CHANGE ORDER (CO) FORM

Contractor:	APAC Kansas Inc., Shears Division					
Engineer:	Professional Engineering Consultants, P.A.					
Agreement Name:	2025 Street Maintenance Improvement – Pavement & Curb Repairs					
Agreement Scope:	Approximately 63,609 SY of Asphalt Mill & Overlay with various other street repairs					
Agreement Date:	03/26/25					
Agreement Price:	\$1,219,247.70	Agreement Time:	75 days

Change Order No: 4

Date of Issuance: 05/22/25

EXHIBIT A

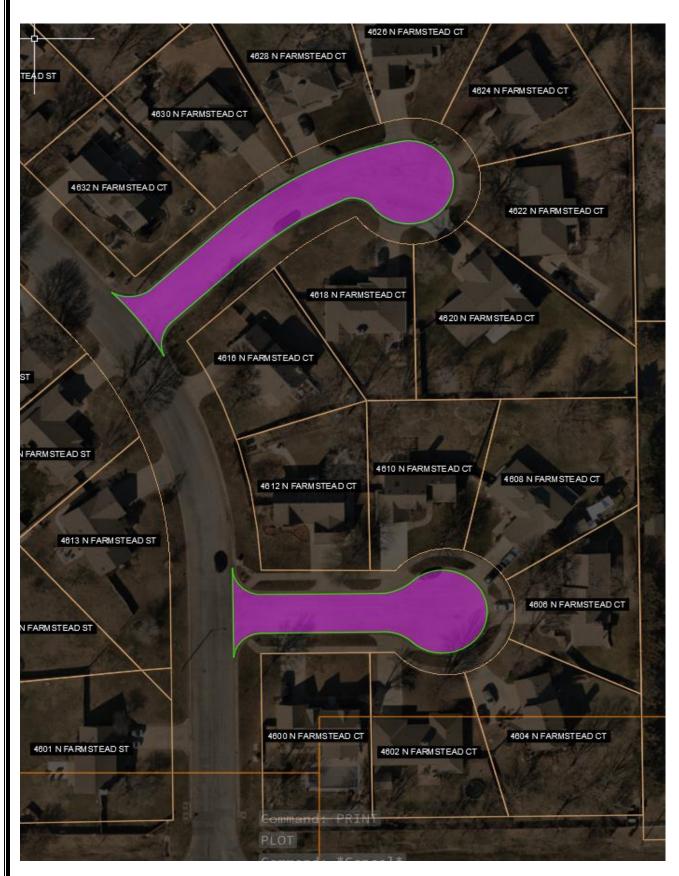
Additional Work as shown on the map (Exhibit A):

Pavement Removal and Full Depth Asphalt Repair as shown on the map (Exhibit A.)

APAC began their mill and overlay of the three cul-de-sacs on Farmstead Court. Two of the cul-de-sacs proceeded as expected but one scheduled for partial depth replacement requires a full depth replacement. Additionally, the city engineer inspected the site on 05/22/25 and recommends not only replacing the cul-de-sac portions but each section of road from the cul-de-sac to Farmstead (not in the original scope.)

*This total cost includes full reconstruction on the two south Farmstead Court cul-de-sacs including the bulbs and the rest of the cul-de-sac to the Farmstead return. It also includes double rock thickness on the southmost cul-de-sac. The asphalt for overlay previously scoped, is deducted.
